# LIBERTY HIGH SCHOOL NEW CLASSROOMS

## Bid Clarification 03

8/22/2022

**DSA File Number: 07-H4**  
**DSA Application Number: 01-119994**  
**PTN: 61721-83**

**PREP ROOM B102**  
1/4" = 1'-0" A-B2.1

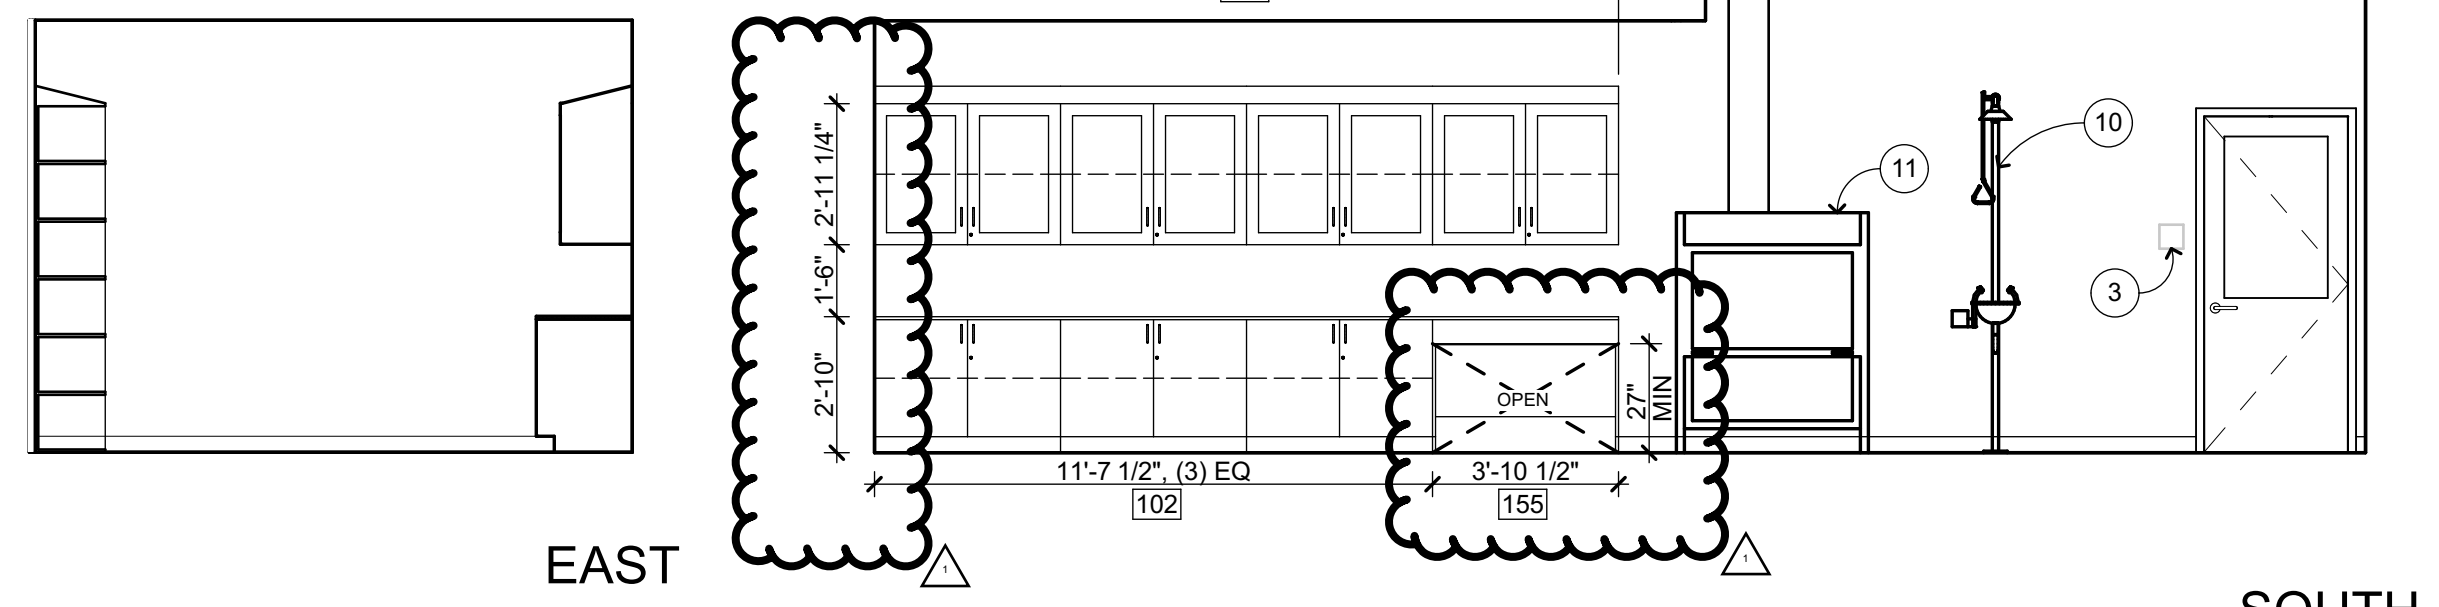
Q: Per Bid Clarification #1, Item No. 1.15, wood laboratory cabinets should be used in the science classrooms. Does this include Prep Room B102?

A Yes wood laboratory cabinets should be used included in the Prep Room B102
